DECLARATION STATEMENT - RECORD OF DECISION

Nepera, Inc. - Harriman Inactive Hazardous Waste Disposal Site Harriman, Orange County, New York Site Number: 336006

RECORD OF DECISION

NEPERA, INC. - HARRIMAN SITE Harriman, Orange County, New York Site Number 3-36-006 March 1997

figure 2
STUDY AREAS
HARRIMAN, NEW YORK

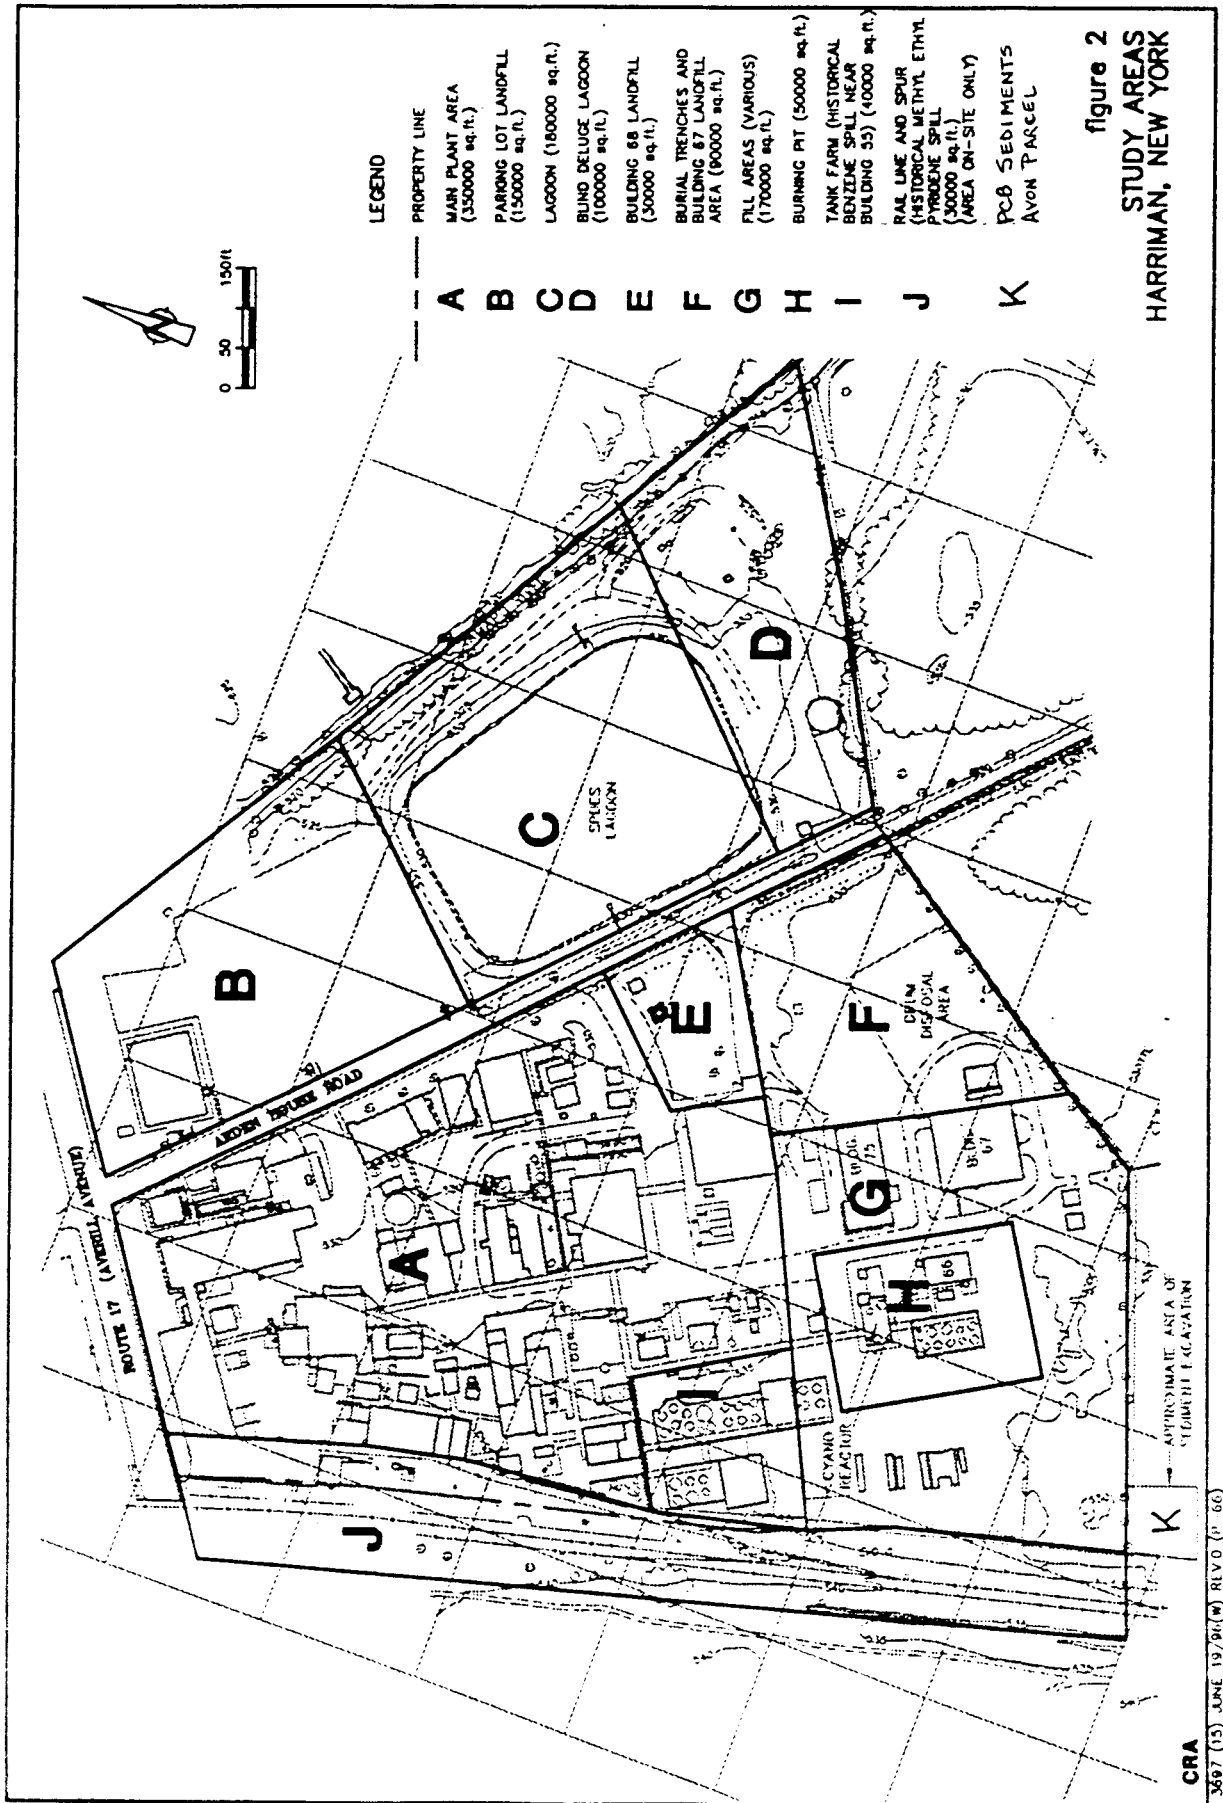
D7. *The legend for Study Area K (Figure 2) should be changed from “PCB Sediments” to “Contaminated Sediments”. The excavation of the sediments on the Avon Parcel is based on the RI sediment sample results indicating levels of SVOCs, PAHs, and PCBs.*

A: This request was incorporated into Figure 2 of this ROD.

Figure 3 - Monitoring Well Network

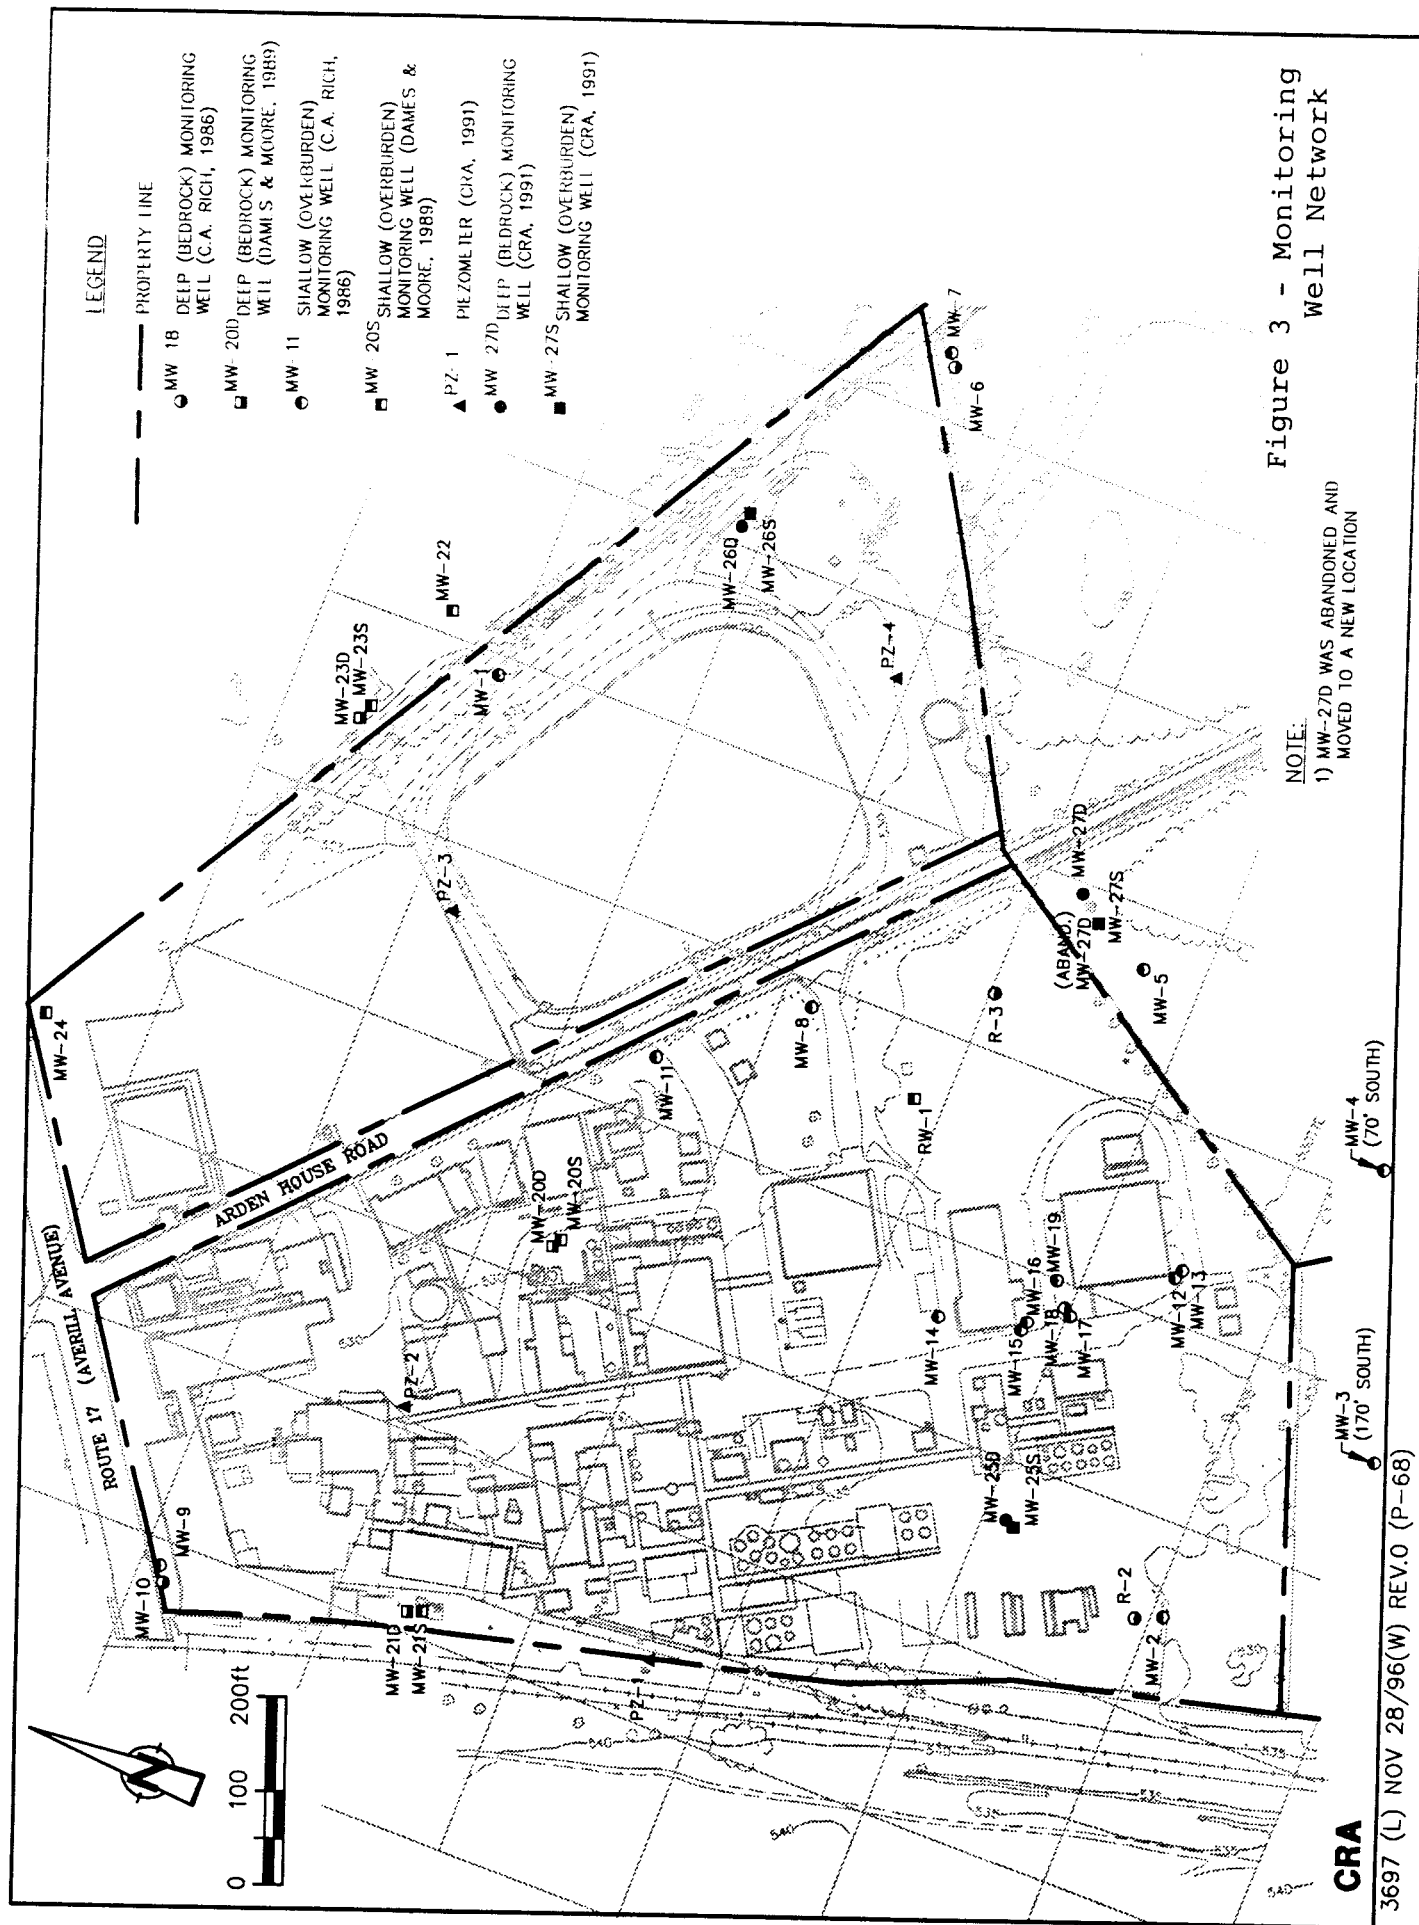
B1. *On Page 5 of the PRAP, there is a reference to the thirty-three wells that comprised the monitoring well network during the RI/FS. Please incorporate a figure into the ROD on which the locations of these wells are shown.*

A: The locations of these wells are shown on Figure 3 of this ROD.
